# City of Corpus Christi

## Meeting Agenda Planning Commission

Wednesday, September 2, 2020

**TECHNICAL REVIEW PLAT REQUIREMENTS  
REGULAR PLANNING COMMISSION MEETING  
SEPTEMBER 2, 2020**

2. [20-1057](#) 20PL1048  
HIGHWAY VILLAGE SECTION 2, BLK 12, LOTS 1A, 1B & 2A (FINAL - 0.90 ACRES)  
Located south of Basket Street and west of Countiss Drive.

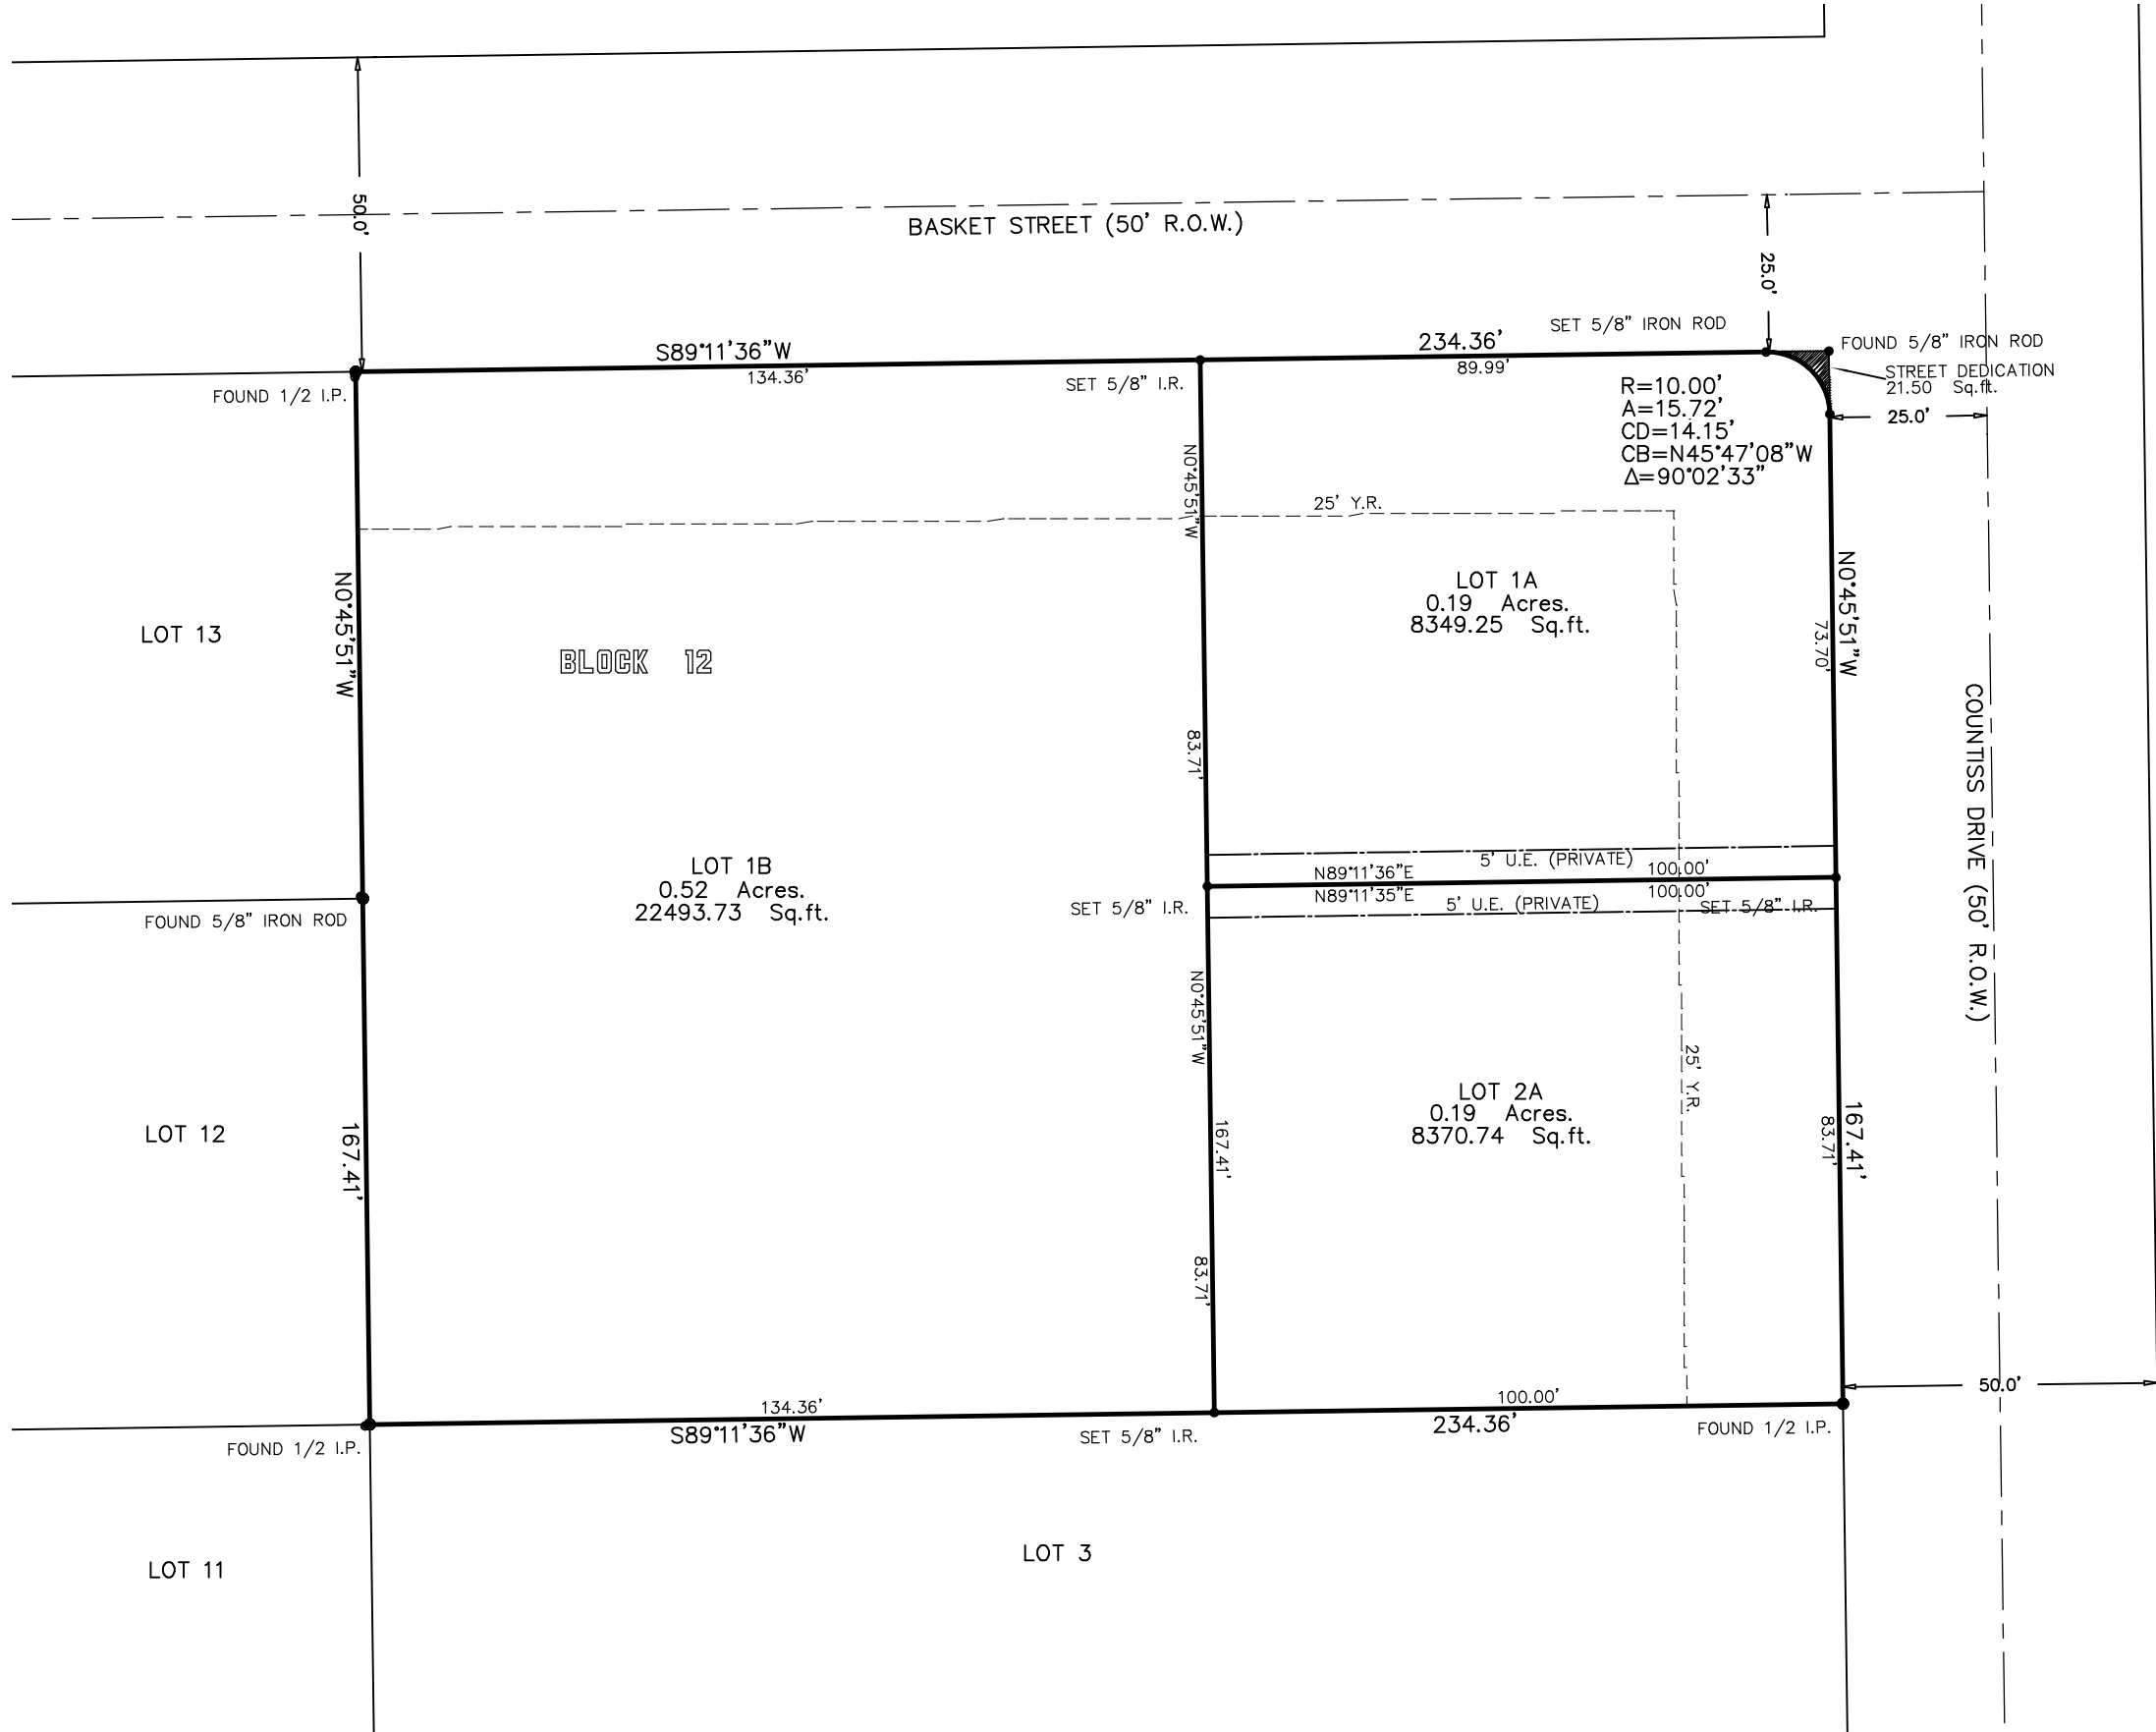
1	Plat	On the owners certificate block label along the signature lines Benjamin Cobos and Karla Cobos title as "Owner"	DONE	Addressed		
2	Plat	On the Engineering certificate block change "Pablo Martinez P.E" to "Jalal Saleh, P.E."	DONE	Addressed		
3	Plat	Show and label a 25' Y.R along both street frontages. (Reference Vol. 11, Page 59).	ADDED	Addressed		
4	Plat	Water Lot fee - 2 lots x \$182.00/Lot <b>\$364.00</b> (Lots 1A & 2A)	NOTED	Prior to plat recordation		
5	Plat	Wastewater Lot fee - 2 lots x \$393.00/Lot = <b>\$786.00</b> (Lots 1A & 2A)	NOTED	Prior to plat recordation

1	Plat	Public Improvements Plans are required at the Final Plat stage; submit a pdf copy of proposed public improvements along with a title sheet to PublicImprovements@cctexas.com for review and approval; this item is required prior to Final Plat Recordation. UDC 8.1.3.A	IF YOU SEE THE ATTACHED UTILITY PLAT WE SUMMITTED, THERE IS NO NEED FOR THE WASTE WATER LINE TO BE CONSTRUCTED. WE ARE GOING TO USE THE EXISTING LINE.	Addressed: Will use existing wastewater service line and will dedicate a private UE over it.		
2	Plat	Label the Utility plan as a “Utility Plan”.	DONE	Addressed		
3	Plat	On the Utility Plan, Show and locate the existing structure with dimensions to the front and side lot lines.	DONE	Addressed		
4	Plat	On Utility Plan, show and label the 6” ACP on Baskett Street.	DONE	Addressed		
5	Plat	On the Utility Plan, show and locate the existing water and waste water service lines from the public connection to the existing structure.	DONE	Addressed

UTILITIES ENGINEERING						
No.	Sheet	Comment	Applicant Response	Staff Resolution	Applicant Response	Staff Resolution
1	Plat	No water construction is required for platting.	NOTED	Addressed		
2	Plat	Wastewater construction is required for platting.	PLEASE READ DEVELOPMENT SERVICES NOT 1.	Addressed: Will use existing wastewater service line and will dedicate a private UE over it.

TRAFFIC ENGINEERING						
No.	Sheet	Comment	Applicant Response	Staff Resolution	Applicant Response	Staff Resolution
1	Plat	Proposed driveway access to a public City Street shall conform to access management standards outlined in Article 7 of the UDC	NOTED

# Request for Sidewalk Waiver

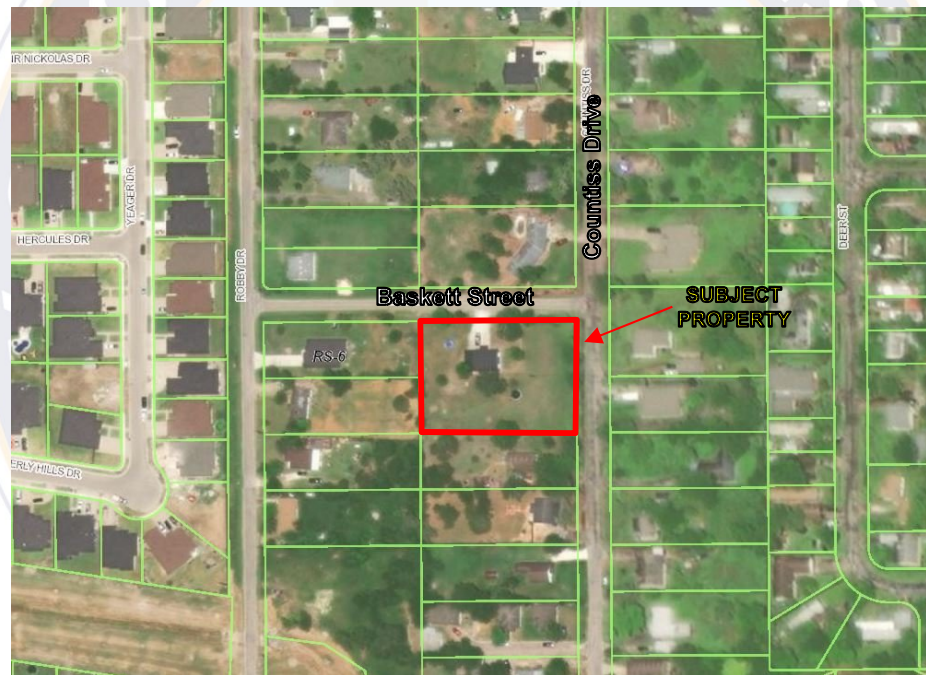
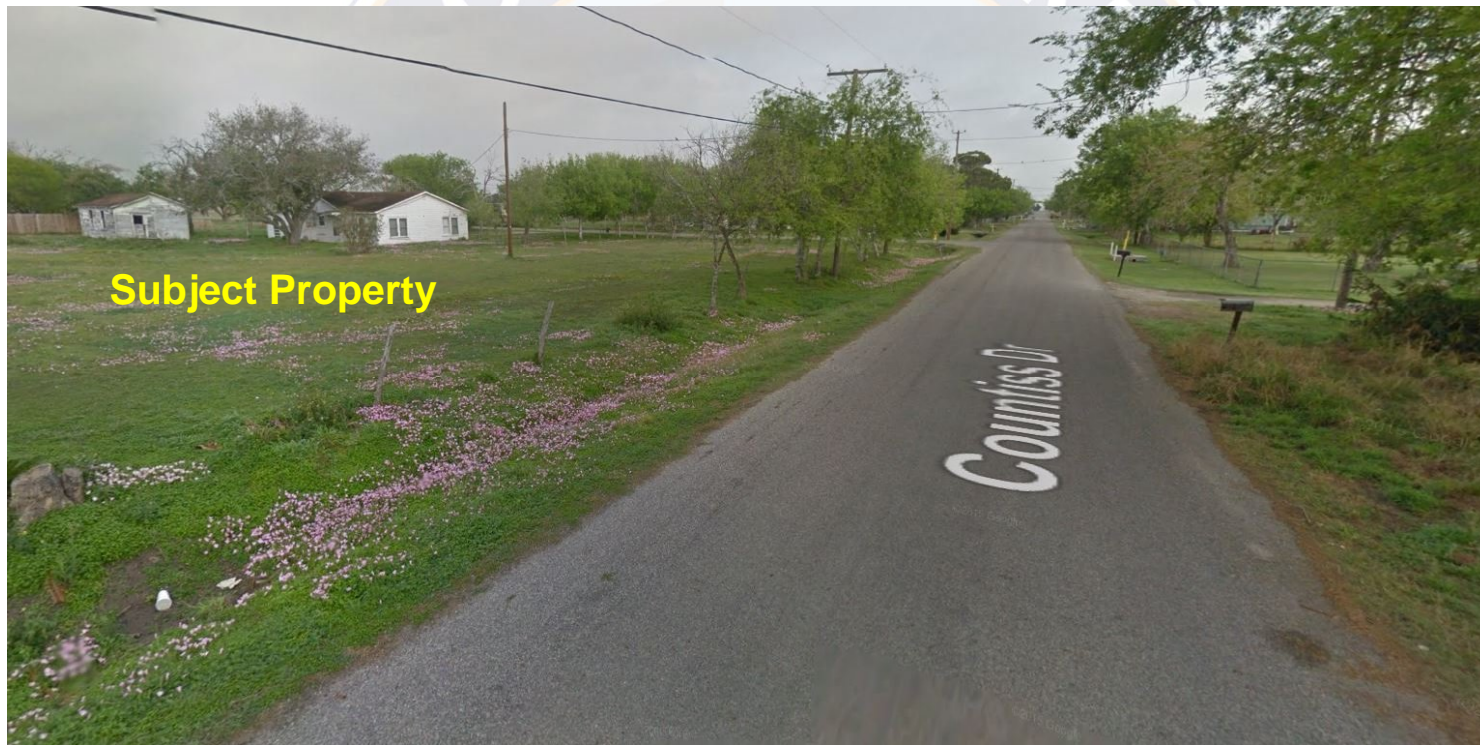
1. No current sidewalk network exists along Baskett Street or Countiss Drive. The subdivision was approved with a rural street section containing ditches. The nearest sidewalk is on a new subdivision off McKinzie Road on the next block. Baskett Street does not continue or connect to this neighborhood. The north road intersection with Leopard Street does not have a sidewalk network.
2. The property is not located along an existing or foreseeably planned CCRTA fixed route service.
3. Waiver of sidewalk will not be detrimental to the public health, safety, or general welfare, and adjacent property will not be restricted or rendered unfeasible.
4. The Comprehensive Plan will not be substantially affected.

4. [20-1055](#) 20PL1063  
CORPUS CHRISTI (407) ADDITION, BLOCK 1, LOT 1 (FINAL - 2.716 ACRES)  
Located west of Linn Street and north Leopard Street.

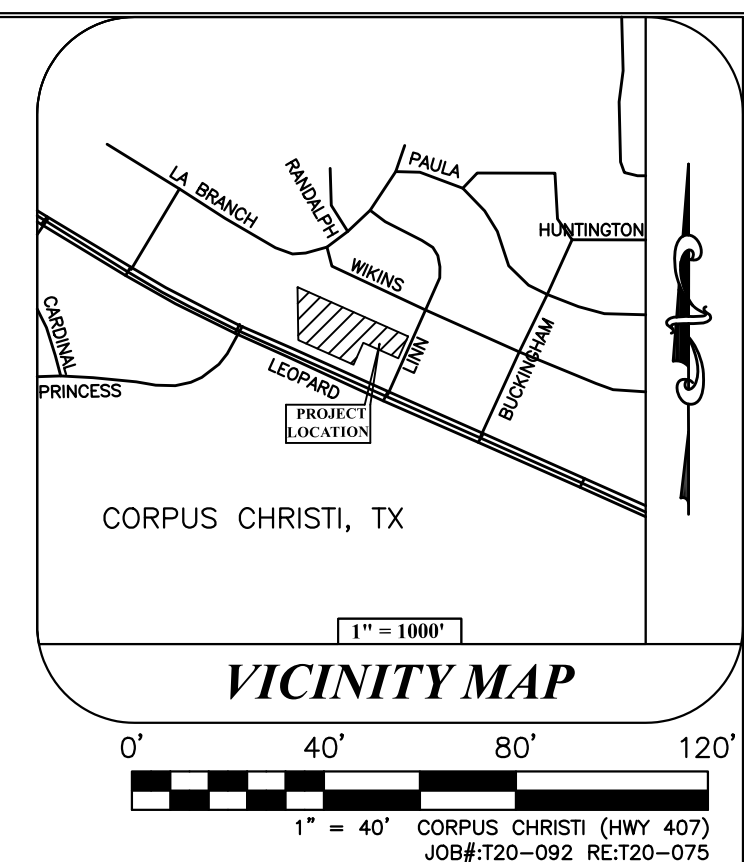
LAND DEVELOPMENT						
No.	Sheet	Comment	Applicant Response	Staff Resolution	Applicant Response	Staff Resolution
1	Plat	Revise and enlarge the plat title to read: "Final Plat Corpus Christi (407) Addition, Block 1, Lot 1..."	Plat title enlarged and revised.	Addressed		
2	Plat	On the <del>owners certificate</del> Planning Commission certificate block on the signature line label "Carl Crull, P.E Chairman" and "Al Raymond III AIA Secretary"	Owners signature line label revised.	Staff Error: Not Addressed	Revised ownership signature line and planning commission signature blocks.	Addressed
3	Plat	Remove the health certificate block	Health certificate block removed from plat.	Addressed		
4	Plat	On the Engineering certificate block revise the signature line to read: "Jalal Saleh, P.E Development Services Engineer"	Engineering certificate block revised.	Addressed		
5	Plat	Remove plat note #6 referencing property zoned	Plat note #6 removed.	Addressed

6	Plat	On plat note 5 identify within which flood zone and indicated on the plat.	Plat note #5 revised to show flood zone identification.	Not Addressed: Note 3: Flood Zone X boundary must be identify on the plat.	Nearest zone boundary is over 1 mile away. The project is completely within Zone X. See Firmette attached to email resubmittal.	Addressed
7	Plat	Under plat note #6 remove the property owner.	Removed the property owner.	Addressed		
8	Plat	The receiving Storm water quality management note is missing on the plat notes (reference SWQMP Report).	Plat revised to show Storm Water Quality Management note.	Addressed		
9	Plat	Add the following "Total Platted Area" standard note to the plat: The total platted area contains x.xx acres of land.	Plat revised to show Total Platted Area standard note.	Addressed		
10	Plat	Add the following "Yard Requirement" standard note to the plat: The yard requirement, as depicted, is a requirement of the Unified Development Code and is subject to change as the zoning may change.	Plat revised to show the Yard Requirement standard note.	Addressed

11	Plat	Add the following standard "Public Open Space" standard note: "If any lot is developed with residential uses, compliance with the open space regulation will be required during the building permit phase."	Plat revised to show Public Open Space standard note.	Addressed		
12	Plat	On the plat remove all public utilites along both street frontages.	All public utilities along both street frontages removed.	Not Addressed	Removed remaining text for utility labels.	Addressed
13	Plat	Show and label the centerline and total ROW dimension for Leopard Street and Linn Street.	Plat revised to show centerline and ROW dimension for Leopard Street and Linn Street.	Not Addressed: The entire street ROW is 60'. Cross hatched and label the additional street dedication to meet 30' half steet centerline (reference Vol 22, Page 22).	Dedicated 0.004 of an acre to the public to meet 30' half street ROW.	Addressed

14	Plat	Remove the contours shown on the plat.	Contours removed from the plat.	Addressed		
15	Plat	Add the square footage for Block 1, Lot 1 and remove only ownership reference.	Plat revised to show square footage for Block 1, Lot 1 and ownership reference removed.	Not Addressed: Ownership reference for Block 1, Lot 1 was not removed.	Ownership reference removed.	Addressed
16	Plat	Remove only the ownership reference for "Arlington Heights Unit 2"	Ownership reference for "Arlington Heights Unit 2" removed.	Addressed		
17	Plat	Remove only the ownership reference for the abutting property to the north "Arlington Heights."	Ownership reference for the abutting property to the north "Arlington Heights" removed.	Addressed		
18	Plat	Remove only the ownership reference for the abutting property to the northwest "Westwood Center Annex."	Ownership reference for the abutting property to the northwest "Westwood Center Annex" removed.	Addressed

No.	Sheet	Comment	Applicant Response	Staff Resolution	Applicant Response	Staff Resolution
1	Plat	Add the following Corpus Christi Inner Harbor Drainage Basin "Receiving Water" standard note to the plat: The receiving water for the storm water runoff from this property is the Corpus Christi Inner Harbor. The TCEQ has classified the aquatic life use for the Corpus Christi Inner Harbor as "intermediate".	Plat revised to show the Corpus Christi Inner Harbor Drainage Basin "Receiving Water" standard note.	Delete Note 7 on the plat; the note indicates "Laguna madre"	Deleted Note 7.	Addressed
2	Plat	Add the following note "all driveways to public Streets within the subdivision shall conform to access management standards outlined in Article 7 of the UDC".	Plat revised to show note.	Addressed

3		Public Improvements Plans are required; submit a pdf copy of proposed public improvements including sidewalks along Leopard Street and Linn Street along with a title sheet to PublicImprovements@cctexas.com for review and approval; this item is required prior to Final Plat Recordation. UDC 8.1.3.A	A PDF copy of the proposed public improvement including sidewalks along the frontage of Leopard Street and the frontage of Linn Street of the proposed Lot 1, Block 1 of the Corpus Christi (407) Addition, with a title sheet will be emailed by the project engineering firm, Linfield, Hunter and Junius, Inc.	Submit PI Plans to the following email address PublicImprovements@cctexas.com	Public Improvement plans have been submitted, see attachment in email resubmittal.	Prior to Plat Recordation
4	Plat	Remove all contours and utilities from the Plat document.	Contours and utilities removed.	Addressed

5	utility Plans	Submit the UE for the proposed Water line / FIRE Hydrant for processing and recordation to ContractsAndAgreements@cctexas.com.	Proposed UE for the proposed waterline and fire hydrant emailed to ContractsAndAgreements@cctexas.com.	Will be addressed with PI Plans.		
6	Storm Study	provided were confusing; indicate the pre-development, the post-development for the fully developed condition for the entire site and the differential Q's WITHOUT DETENTION and then another set WITH DETENTION in CFS for the 5, 25, and 100 year storm for the site; please include all the storm study calculations on the	Please see revised Stormwater Quality Management Plan, prepared by Linfield, Hunter & Junius, Inc., where Table 3 on page 4 has been replaced with Table 3: (Flow Rate Values (Prior to Detention) - 5 Year, 25 Year and 100 Year Design Storm Frequency and Table 4: Flow Rate Values (With Detention) - 5 Year, 25 Year and 100 Year Design Storm Frequency. The tables provided in the report have also been provided on the engineering sheets within the report.	Addressed

No.	Sheet	Comment	Applicant Response	Staff Resolution	Applicant Response	Staff Resolution
1	Plat	Water construction is required to provide fire hydrants at a maximum spacing of 300' on center and to provide for the flow of a minimum of 1500 gpm at 20 psi residual.	See civil engineering plans prepared by Linfield, Hunter & Junius, Inc. for proposed fire hydrant location.	Will be addressed with PI Plans.		
2	Plat	No wastewater construction is required for platting.	Noted.	N/A

1	Informational	Proposed driveway access to a public City Street shall conform to access management standards outlined in Article 7 of the UDC	Noted.			
2	Plat	Need to provide dimensions for the proposed driveways to/from close by driveway, and street. This is to verify it meets driveway spacing from other driveways.	See civil engineering plans, sheet C3, prepared by Linfield, Hunter & Junius, Inc. for driveway dimensions.	Addressed 8-11-20
